Access Compliance Report

Public Rights-of-Way

Intersection ID: 13754	Main Street: S_MCDOWELL_ST	Cross Street: BAXTER_ST	Location:	N
ADA ID: 6EF58E6CF99A	Ramp Type: PerpDiag	Initial Pass/Fail: Fail	Overall Compliance: No	Severity Score: 37.5

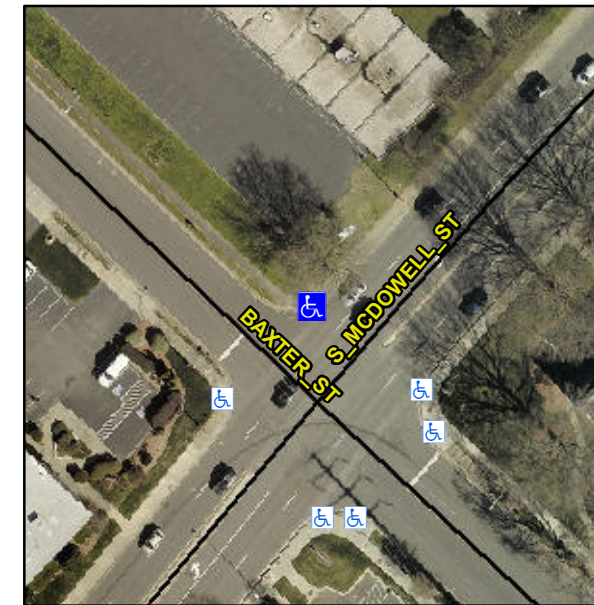
R304.2.2, R304.5.3

Compliance	Description	Data	Compliance	Description	Data
N/A	Ramp Length (in)	72.0	No	Ramp Slope (%)	12.3
Yes	Ramp Width (in)	72.0	No	Ramp XSlope (%)	6.4
N/A	Flare Type LT	N/A	N/A	Flare Type RT	N/A
N/A	Flare Slope LT (%)	N/A	N/A	Flare Slope RT (%)	N/A
N/A	Flare Traversable LT?	N/A	N/A	Flare Traversable RT?	N/A
N/A	Landing Length (in)	N/A	N/A	DWS Provided?	N/A
N/A	Landing Width (in)	N/A	N/A	DWS Contrast?	N/A
N/A	Landing Slope (%)	N/A	N/A	DWS Length (in)	N/A
N/A	Landing X Slope (%)	N/A	N/A	DWS Full Width?	N/A
N/A	Landing Curb? (Y/N)	N/A	N/A	DWS Offset (in)	N/A
N/A	Shared Landing?	N/A			
N/A	Gutter Ponding?	N/A	N/A	Gutter Slope (%)	N/A
N/A	Gutter Lip Ht (in)	N/A	N/A	Gutter X Slope (%)	N/A
N/A	Painted X Walk1?	No	N/A	Painted X Walk2?	No
	X Walk 1 Direction	To SW		X Walk 2 Direction	To SE
N/A	X Walk 1 Width (in)	N/A	N/A	X Walk 2 Width (in)	N/A
	X Walk 1 Slope (%)	0.1		X Walk 2 Slope (%)	4.3
	X Walk 1 X Slope (%)	4.9		X Walk 2 X Slope (%)	2.4

Remove & Replace Curb Ramp With Two New Directional Ramps or Equivalent.
